YANKEE ATOMIC ELECTRIC COMPANY

Reference: License No. DFR-3 (Docket No. 50-29)

PROPOSED CHANGE: Reference is made to Section 400 of the license application, Safety Analysis, particularly Page 400:2 and to Paragraph D.2.d of the Technical Specifications attached as Appendix A to the license and as amended in Proposed Changes Nos. 99 and 100. We propose the following:

Proposed Change No. 101
July 6, 1972

ATTACHMENT NO. 1

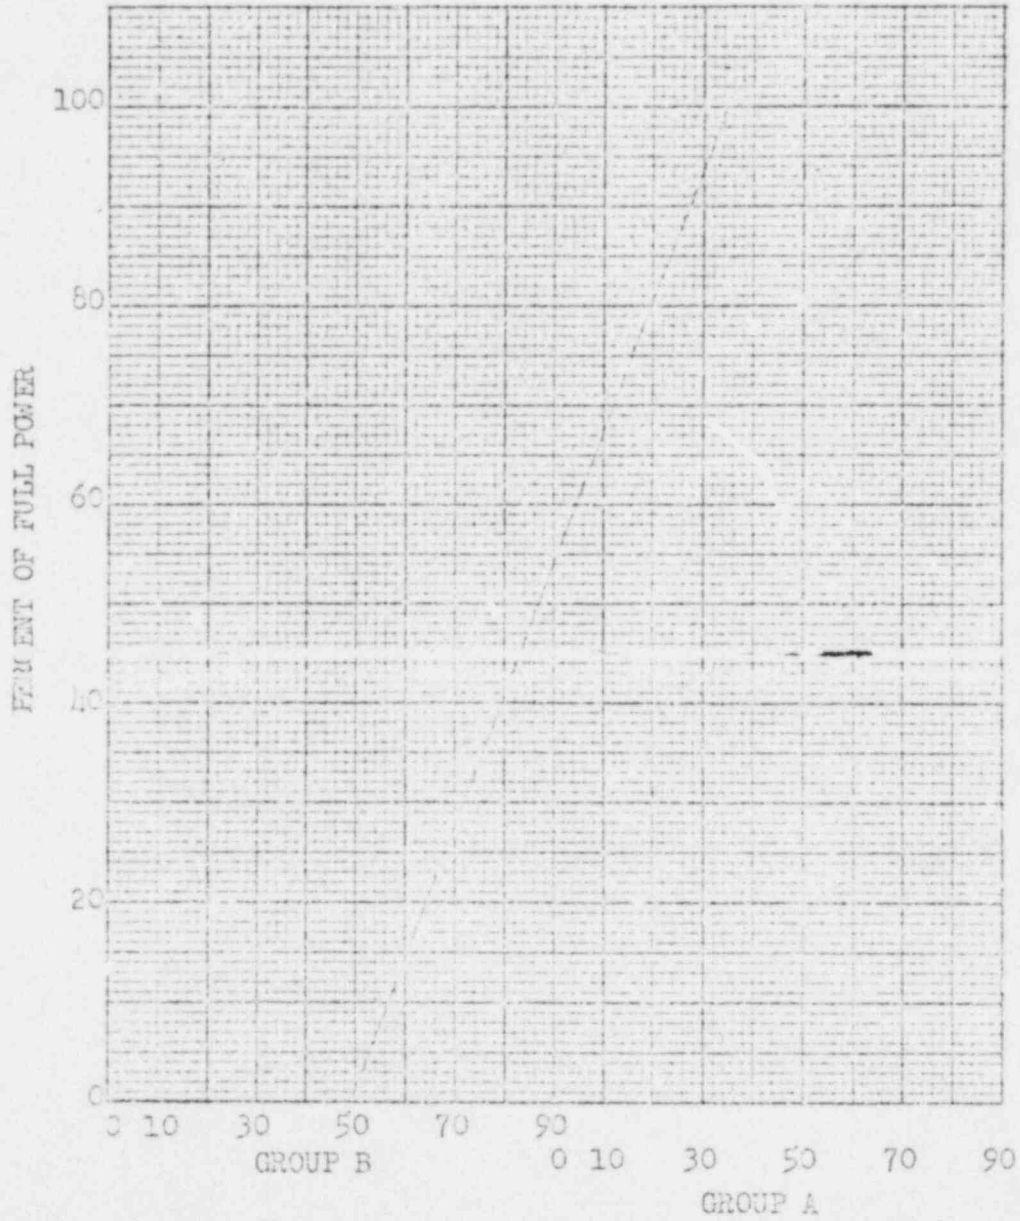
Reason for Change: During the control rod exercise and drop time testing portion of the Core X Start-of-Life testing program, difficulty was encountered with control rod No. 18 located in Shutdown Group D. Results of the test program revealed that control rod No. 18 did not properly drop into the Core. During the subsequent increased surveillance program, control rod No. 18 has successfully dropped on the thirteen occasions that all the control rods have been dropped. The average drop time for control rod No. 18 is 2.65 seconds. To assure that the shutdown margin is maintained without compensating for the entire worth of the maximum worth control rod (1.5% $\Delta K/K$ as specified in Proposed Change No. 100, Yankee proposes to conservatively operate the reactor to compensate for the slow control rod. The control rod position for the control rod at 2.40 seconds shall be conservatively determined using an average drop time of 2.65 seconds (Attachment 1). Reactivity worth of the control rod from above the Core to the bottom of the Core can be determined using 1.50% $\Delta K/K$ as the worth of the entire control rod. Either the reactor power output shall be sufficiently reduced and/or the control rod restriction curve (attached) shall be increased to maintain 2.0 times the worth of the slow control rod between 2.40 and the average measured drop time.

"Operation of the Yankee reactor with increased surveillance and operating restrictions and a control rod dropping with a drop time greater than 2.40 seconds."
